SAN LUIS OBISPO COUNTY
DEPARTMENT OF PUBLIC WORKS

**ADDENDUM NO. 2 TO
MARIA VISTA ESTATES PHASE 3 IMPROVEMENTS
NIPOMO, CA
CONTRACT NO. 300435**

The Contract Special Provisions are hereby amended as follows:

CONSTRUCTION SKETCH

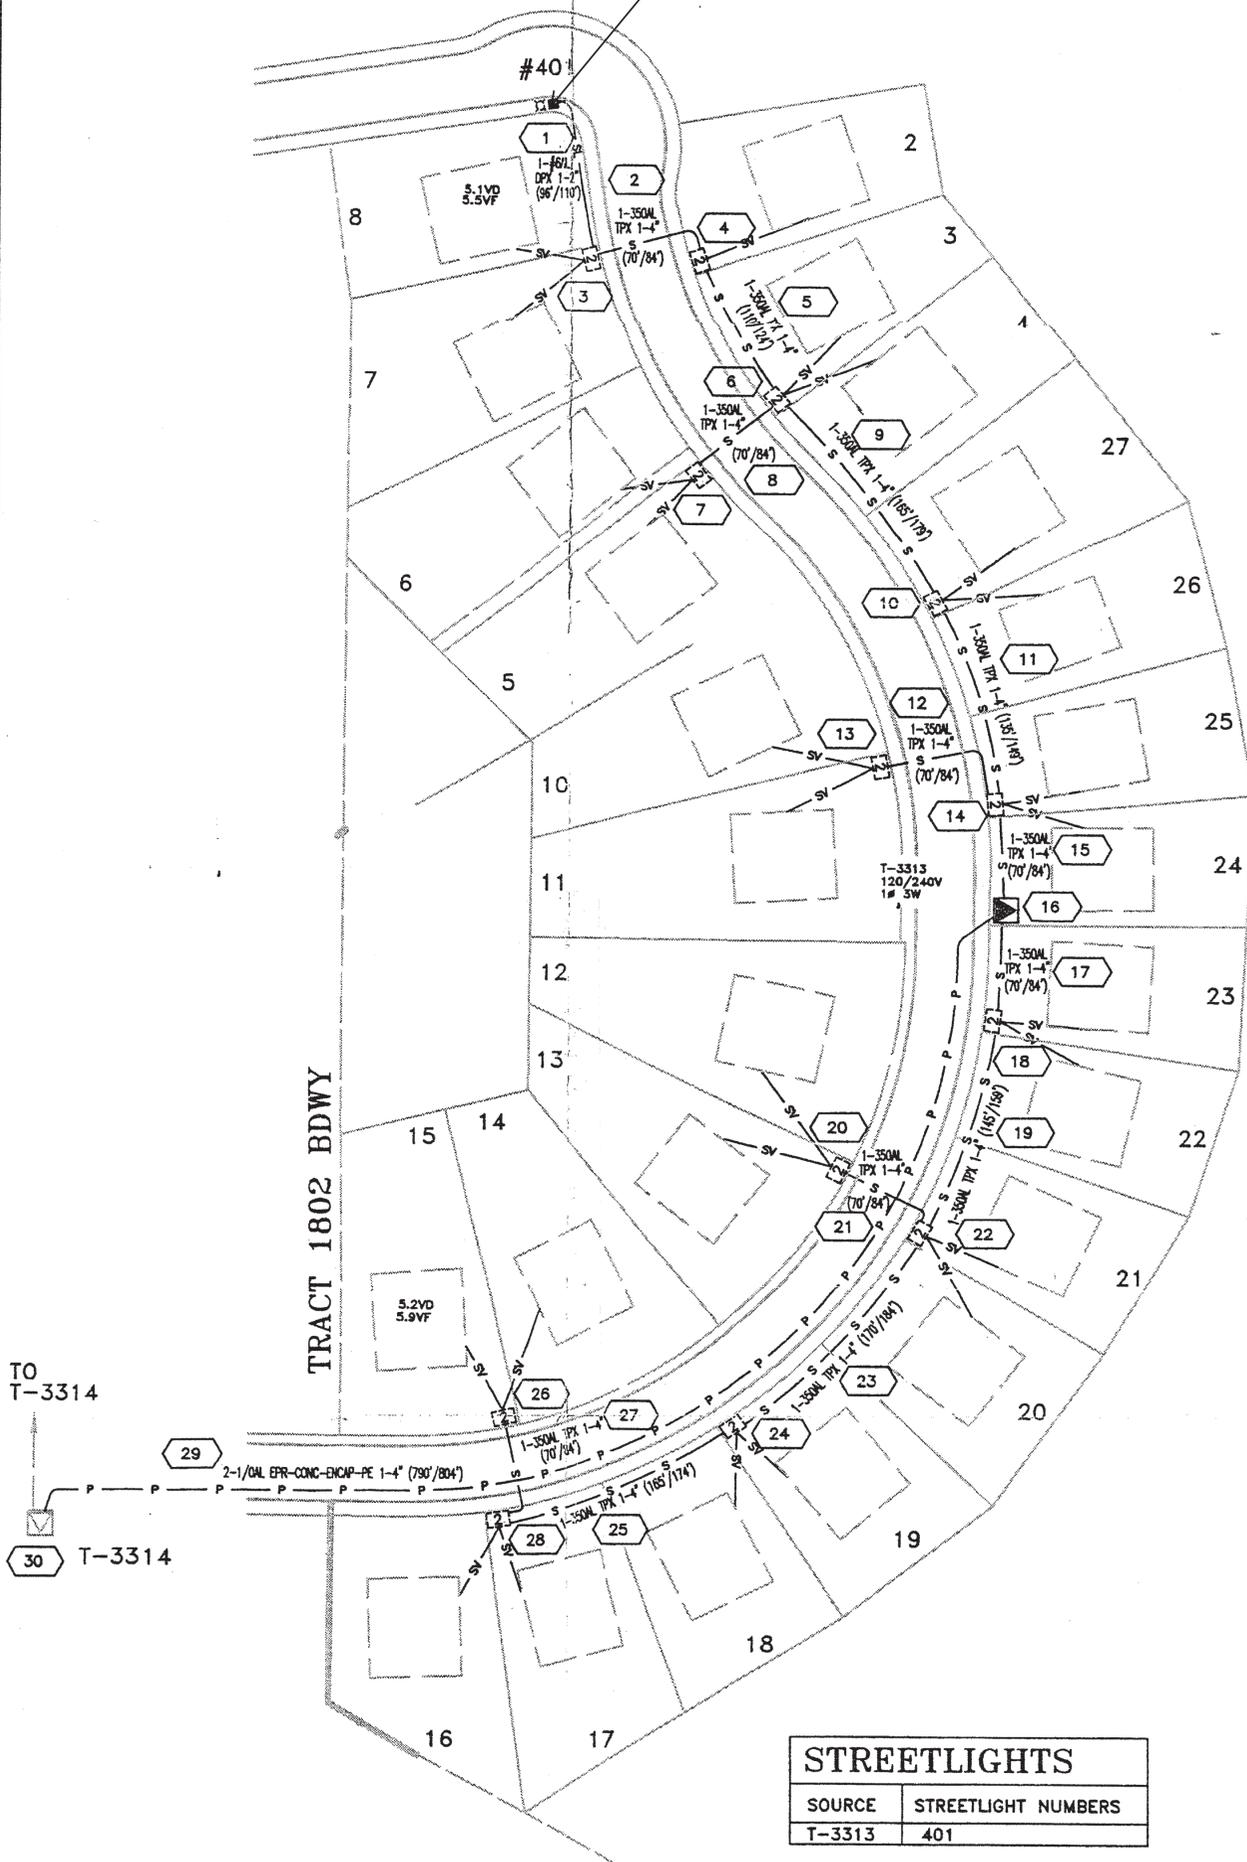
Note that Streetlight #401 is not a part of this work.

This sketch for informational purposes, see other plan sheets for required work.
PG&E Inspector will be present at preconstruction meeting.
PG&E Inspector Contact Information:
Elane Robbins
